**APPENDIX E.5: Minutes and Resolutions for New Items from Study Team by the Letter on  
October 1999**

**THE NORTH SINAI INTEGRATED RURAL DEVELOPMENT PROJECT (PHASE III)**

CONVEYANCE CANAL SYSTEM  
 BETWEEN THE END OF EL EL AND ZONE  
 UNTIL THE BEGINNING OF EL SIR AND EL KAWAR ZONE

Figure V-1 Case A

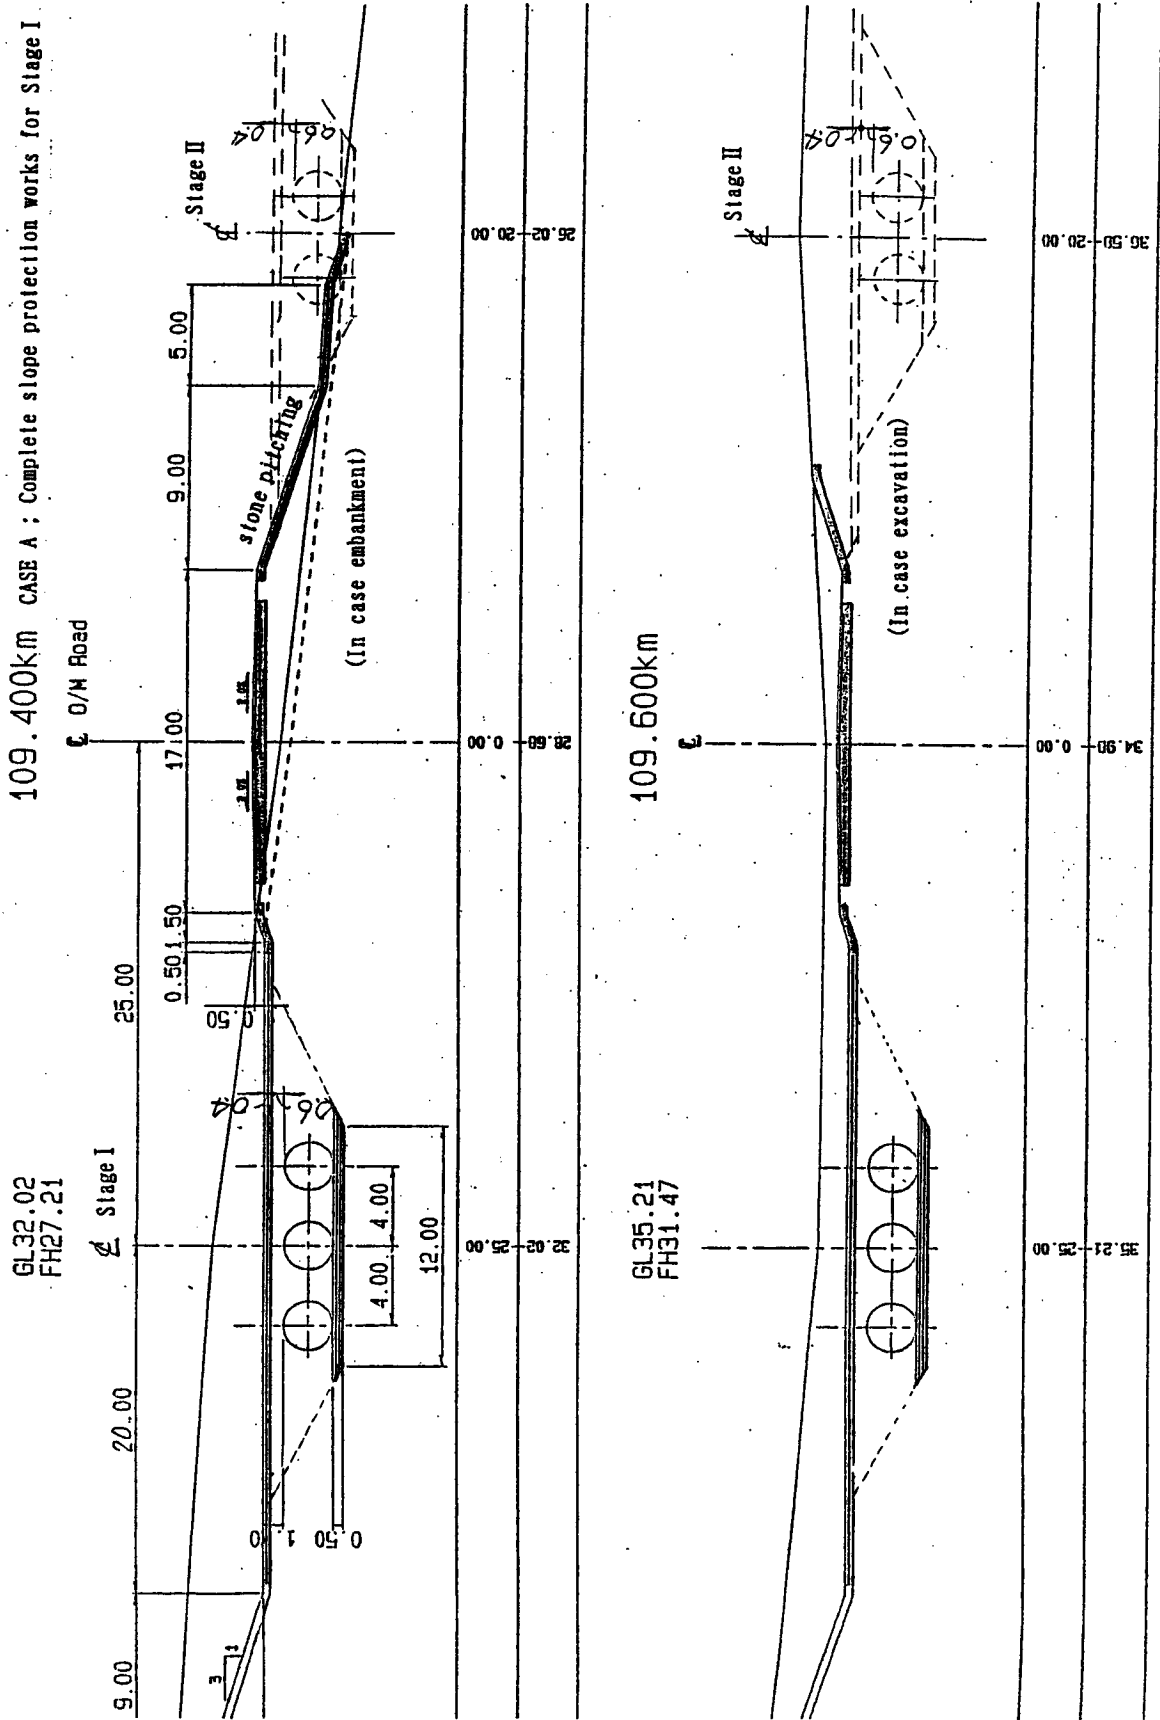
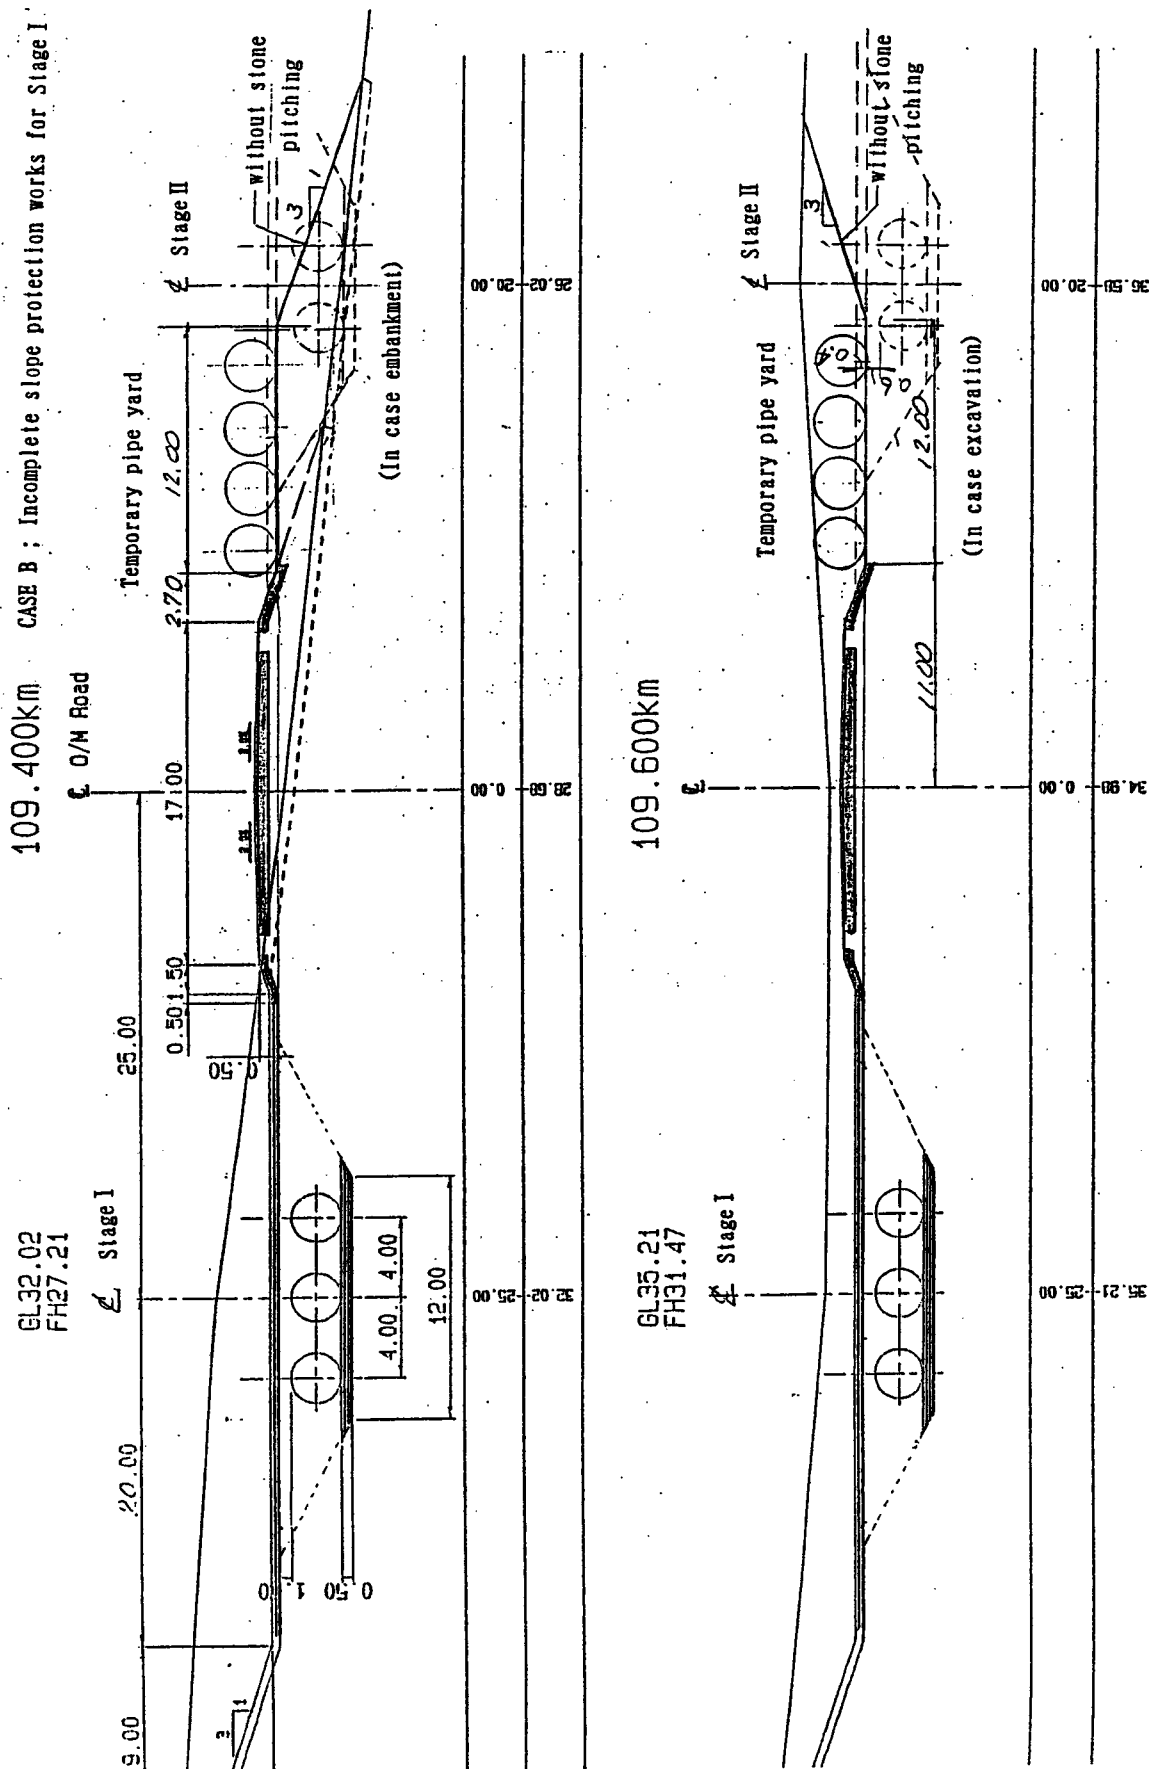
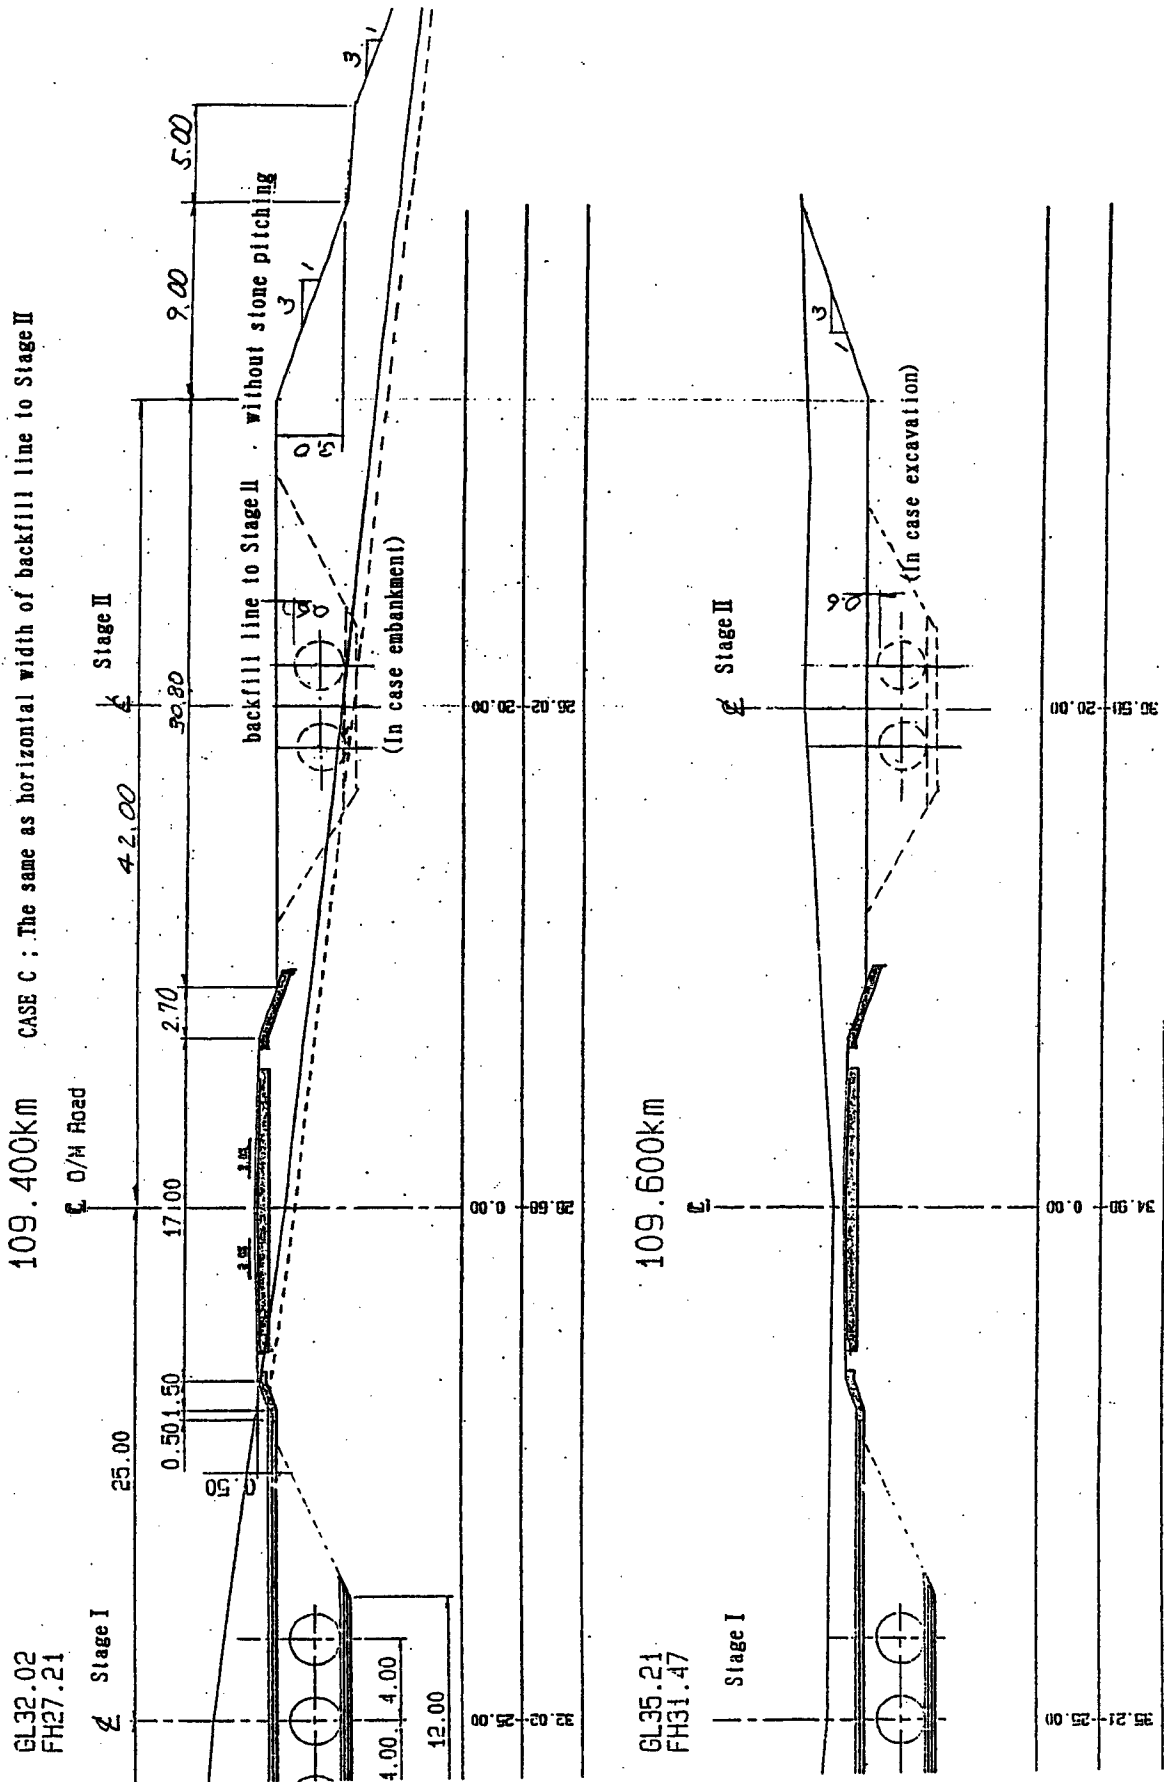
**Item V-01 : The study team proposes suitable construction method of pipeline works for both Stage I and Stage II taking into account stock pile yards and realistic side slope protection.**

Case A : Construction works of the stage I pipeline are completely finished with surface and side slope protection works as indicates in the attached figure Case A. However, this case has no stock pile yard for 2,400mm steel pipe during the construction period and some part of the existing stone pitching (side slope protection) will be demolished before commencement of stage II pipe installation works.

Case B : Construction works of the stage I pipeline are completely finished with stock pile yard for stage I pipeline installation as illustrated in the figure Case B. Minimum width of stock pile yard is about 12 m for stage I pipeline installation.

Case C : Construction works of the stage I pipeline are completely finished with necessary protection works and earth work of both excavation and embankment will be finished for stage II considering stock pile yards for pipe installation of stage I as indicated in the figure Case C, except excavation and compaction of core parts of pipe installation for stage II.

Resolution : The conclusion of study team is Case B, because stock pile yard of pipe installation is necessary and temporary work for stage II shall be minimized taking into consideration of time interval of stage I and II project implementation.

Figure V.2-1 Typical Cross Section of Inverted T-Shape Type (1)

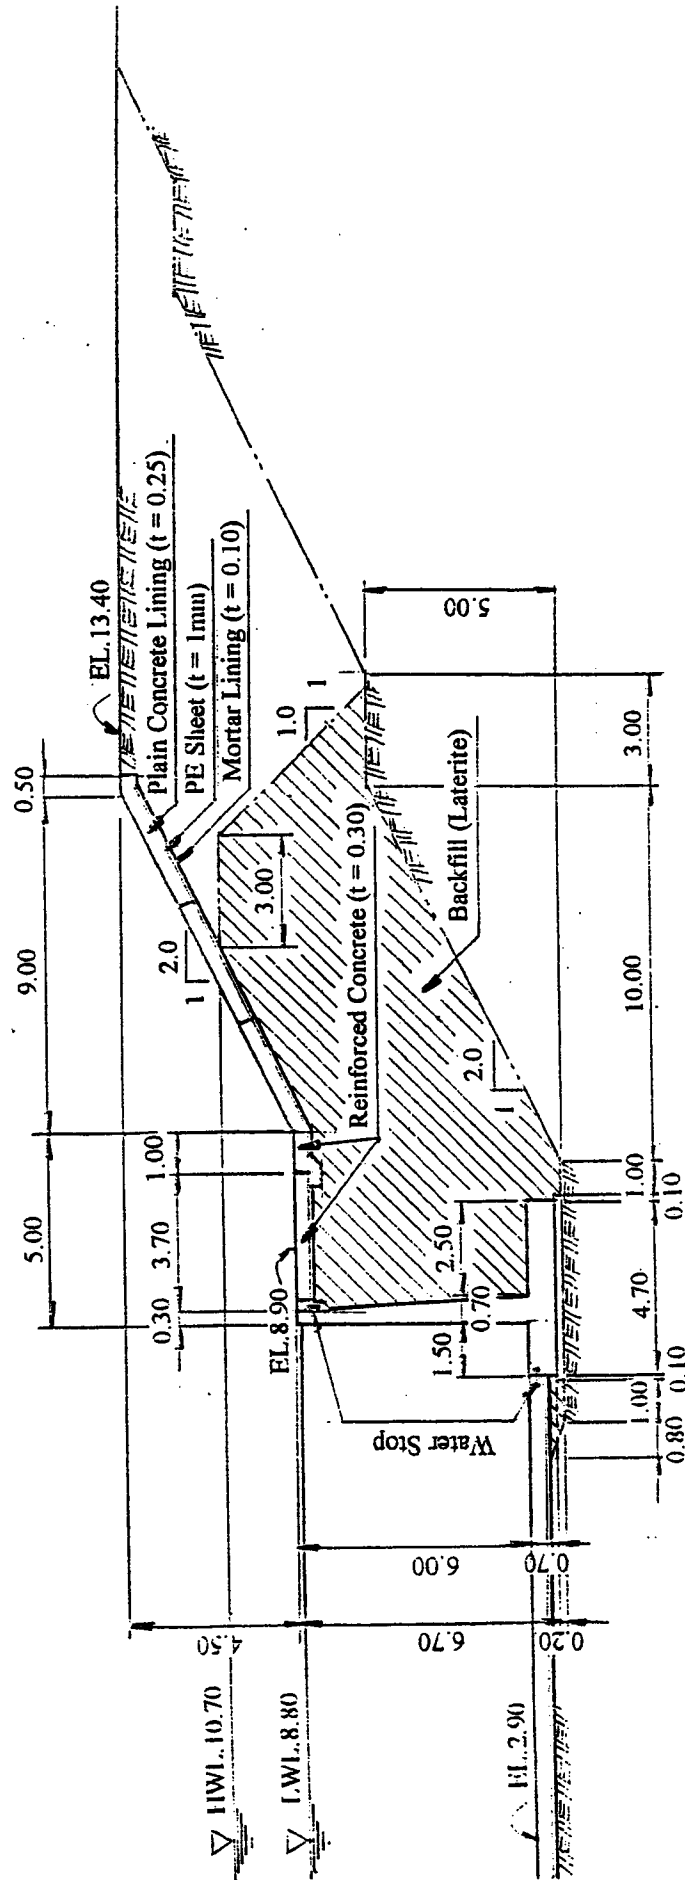
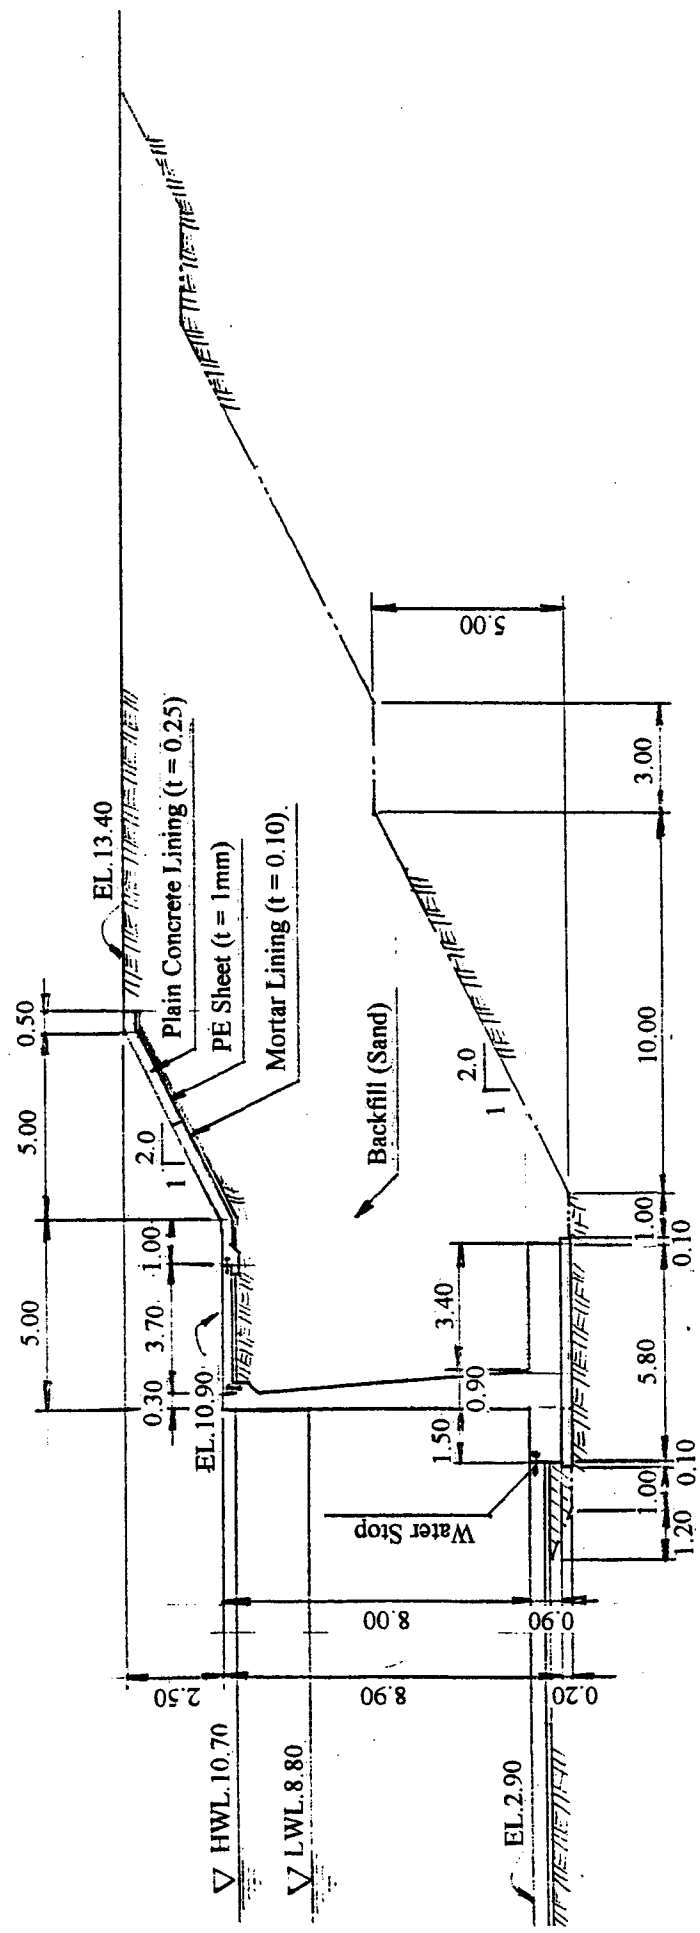
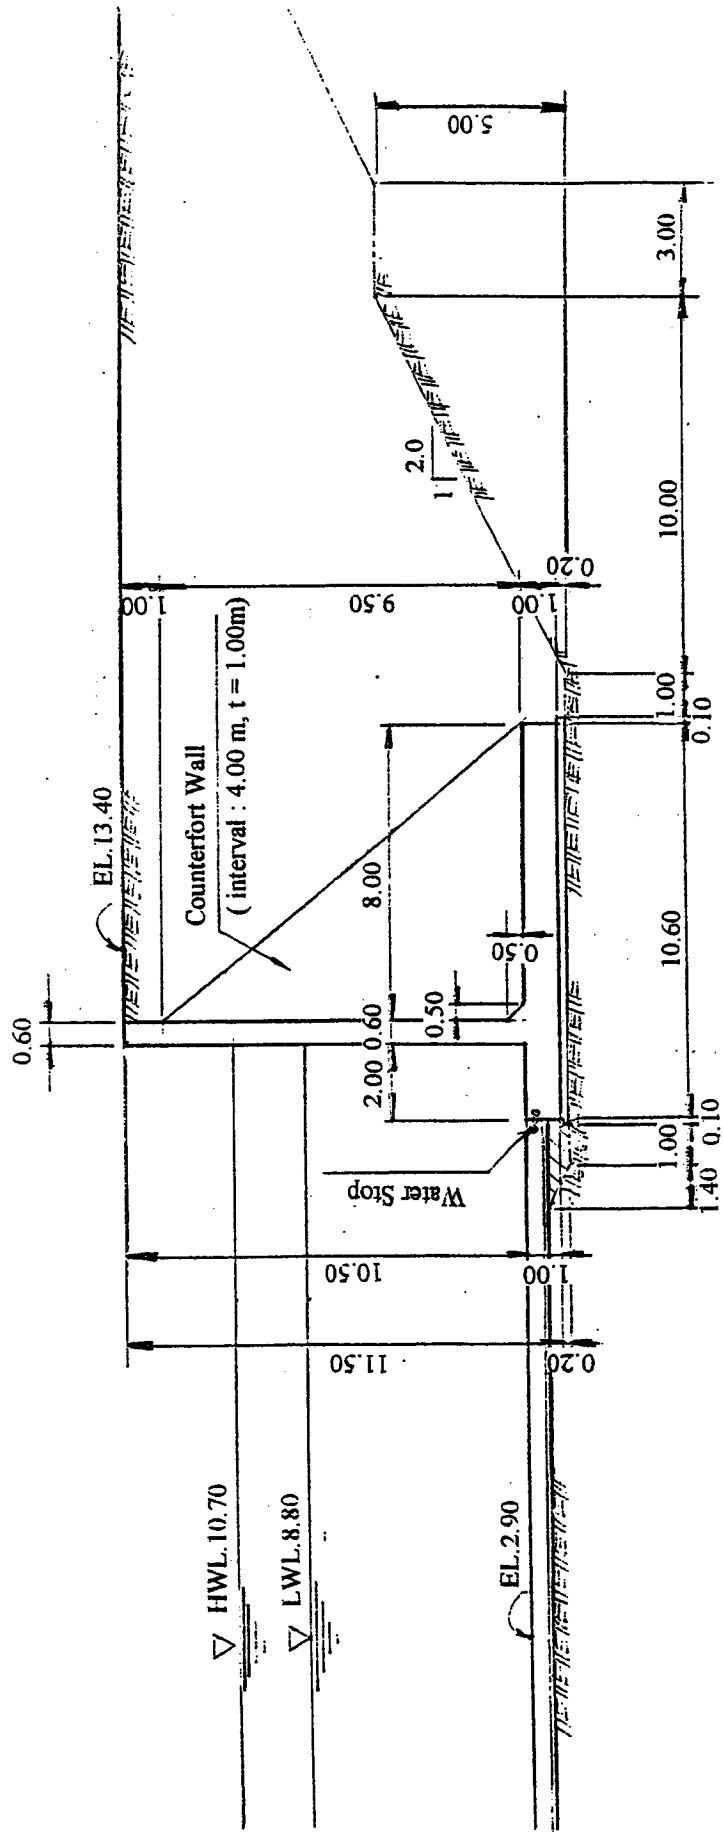
**Item V-02 : The study team proposes recommendable side-wall type of the sand settling basin taking into account structural stability, foundation conditions, easy construction and economy.**

Resolution : According to the Interim Report (2), the side-wall type of the sand settling basin was proposed inverted T-shape type of the height: 6.70m ( lower section ) and slope protection of the height: 4.50m ( upper section ). The followings are possible three types alternatives of side-wall.(Refer to Figure V.2-1, V.2-2 and V2-3)

The conclusion of the study team is Inverted T-shape type of the height: 8.90m with slope protection of the height: 2.5m, because this type is structural safety, no leakage of water, normal construction and most economy.(Refer to Table V.2-1 and V.2-2)
